CHEVY CHASE VILLAGE PARKS – OLIVER STREET (TRIANGLE) PARK  
LANDSCAPE RECOMMENDATIONS  
SEPTEMBER 9<sup>TH</sup>, 2015

Existing Conditions

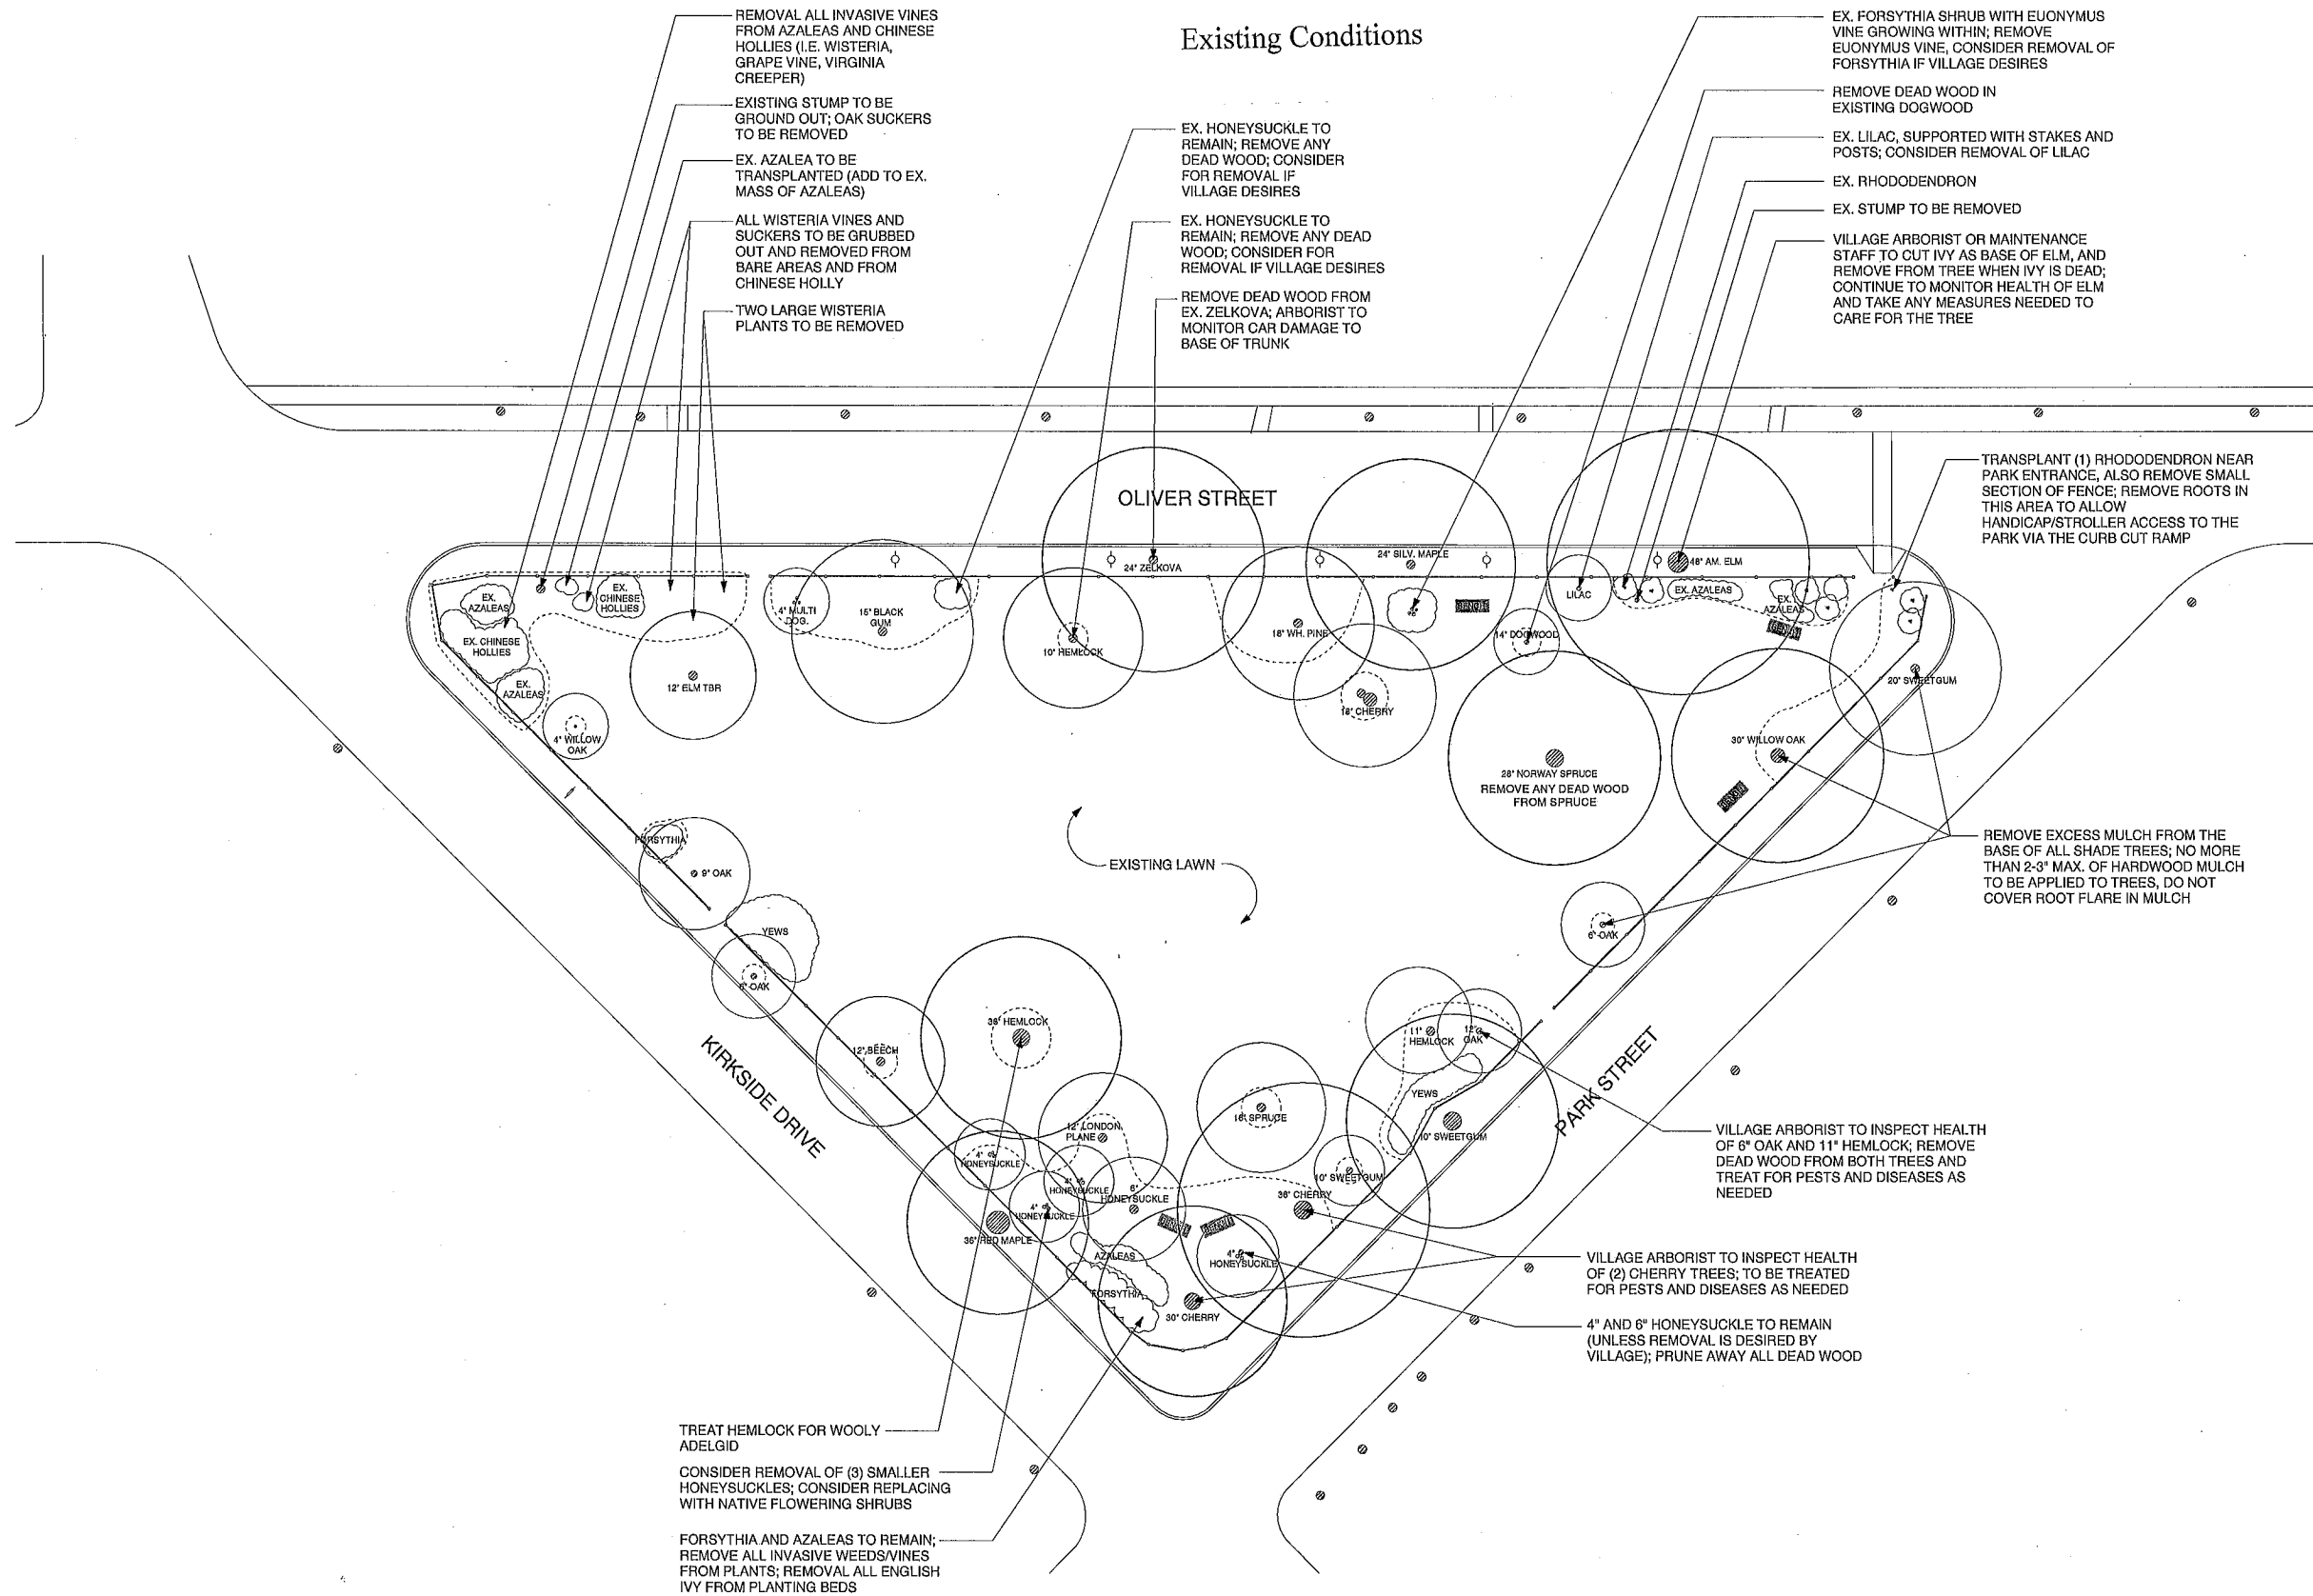
- To increase accessibility, including improved access for wheelchairs and/or strollers, consider removing a small section of existing fencing and transplanting the rhododendron at the northeast park entrance. Following removal of the fencing and shrubs, consider regrading the entry path to be flush with the handicap curb cut and ramp. By realigning the lawn path with the handicap ramp, the park will be easier to access for all who wish to use it.

- Following the removal of non-native and/or unhealthy shrubs (i.e. lilac, forsythia, and honeysuckle) as recommended on the Oliver Street Park plans, consider planting replacement shrubs which add seasonal interest, benefit wildlife, and are native to Maryland. In keeping with Chevy Chase Village's desire to plant mostly native material, we suggest considering a native viburnum, such as the 'Brandywine' or 'Winterthur', to replace any existing shrubs which are designated for removal on the Oliver Street Park plans.

- To enhance the park setting, consider installing a number of new plants and trees at the northwest corner of the park. These new plantings will help to buffer the park from the street, create another focal point within the park, and provide additional fall color, spring bloom, and winter interest.

- Consider adding another bench in the northwest corner of the park. This is the only corner of the park which does not have a bench for sitting, relaxing, and socializing. This corner of the park also offers some of the most expansive views of the park. A new bench placed in this corner would provide an attractive place to sit and read or to watch the play in the center lawn area. This is an area out of the zone of actual play.

- Install mulch rings on all existing (and new) trees and shrubs. The mulch should be installed at a depth of 2-3" maximum and extend no higher than a tree's root flare. Check all existing trees for excessive mulch application. No mulch should be greater than 2" and/or cover the root flare.

- Install a large mulch ring under the existing Norway Spruce. Since grass is struggling to grow, this will help reduce lawn care and protect the roots from damage.

- Remove all dead wood from trees on site. Treat one hemlock for wooly adelgid (see plan).
- Remove all invasive vines and shrubs from planting beds, tree trunks, and shrubs. These included English ivy, wisteria, euonymus vine, fox grape, and Virginia creeper. Where vines are growing on tree trunks, cut the vines at the root prior to removing from the trunk. Remove the vines with care once they are dead.

- Consider aerating the central lawn area and overseeding. This will help create a strong, dense, and healthy lawn. Remove patches of liriopse from lawn area.

REMOVAL ALL INVASIVE VINES FROM AZALEAS AND CHINESE HOLLIES (I.E. WISTERIA, GRAPE VINE, VIRGINIA CREEPER)  
EXISTING STUMP TO BE GROUND OUT; OAK SUCKERS TO BE REMOVED  
EX. AZALEA TO BE TRANSPLANTED (ADD TO EX. MASS OF AZALEAS)  
ALL WISTERIA VINES AND SUCKERS TO BE GRUBBED OUT AND REMOVED FROM BARE AREAS AND FROM CHINESE HOLLY  
TWO LARGE WISTERIA PLANTS TO BE REMOVED

EX. HONEYSUCKLE TO REMAIN; REMOVE ANY DEAD WOOD; CONSIDER FOR REMOVAL IF VILLAGE DESIRES  
EX. HONEYSUCKLE TO REMAIN; REMOVE ANY DEAD WOOD; CONSIDER FOR REMOVAL IF VILLAGE DESIRES  
REMOVE DEAD WOOD FROM EX. ZELKOVA; ARBORIST TO MONITOR CAR DAMAGE TO BASE OF TRUNK

EX. FORSYTHIA SHRUB WITH EUONYMUS VINE GROWING WITHIN; REMOVE EUONYMUS VINE, CONSIDER REMOVAL OF FORSYTHIA IF VILLAGE DESIRES  
REMOVE DEAD WOOD IN EXISTING DOGWOOD  
EX. LILAC, SUPPORTED WITH STAKES AND POSTS; CONSIDER REMOVAL OF LILAC  
EX. RHODODENDRON  
EX. STUMP TO BE REMOVED  
VILLAGE ARBORIST OR MAINTENANCE STAFF TO CUT IVY AS BASE OF ELM, AND REMOVE FROM TREE WHEN IVY IS DEAD; CONTINUE TO MONITOR HEALTH OF ELM AND TAKE ANY MEASURES NEEDED TO CARE FOR THE TREE

TRANSPLANT (1) RHODODENDRON NEAR PARK ENTRANCE, ALSO REMOVE SMALL SECTION OF FENCE; REMOVE ROOTS IN THIS AREA TO ALLOW HANDICAP/STROLLER ACCESS TO THE PARK VIA THE CURB CUT RAMP

REMOVE EXCESS MULCH FROM THE BASE OF ALL SHADE TREES; NO MORE THAN 2-3" MAX. OF HARDWOOD MULCH TO BE APPLIED TO TREES, DO NOT COVER ROOT FLARE IN MULCH

VILLAGE ARBORIST TO INSPECT HEALTH OF 6" OAK AND 11" HEMLOCK; REMOVE DEAD WOOD FROM BOTH TREES AND TREAT FOR PESTS AND DISEASES AS NEEDED

VILLAGE ARBORIST TO INSPECT HEALTH OF (2) CHERRY TREES; TO BE TREATED FOR PESTS AND DISEASES AS NEEDED  
4" AND 6" HONEYSUCKLE TO REMAIN (UNLESS REMOVAL IS DESIRED BY VILLAGE); PRUNE AWAY ALL DEAD WOOD

TREAT HEMLOCK FOR WOOLY ADELGID  
CONSIDER REMOVAL OF (3) SMALLER HONEYSUCKLES; CONSIDER REPLACING WITH NATIVE FLOWERING SHRUBS  
FORSYTHIA AND AZALEAS TO REMAIN; REMOVE ALL INVASIVE WEEDS/VINES FROM PLANTS; REMOVAL ALL ENGLISH IVY FROM PLANTING BEDS
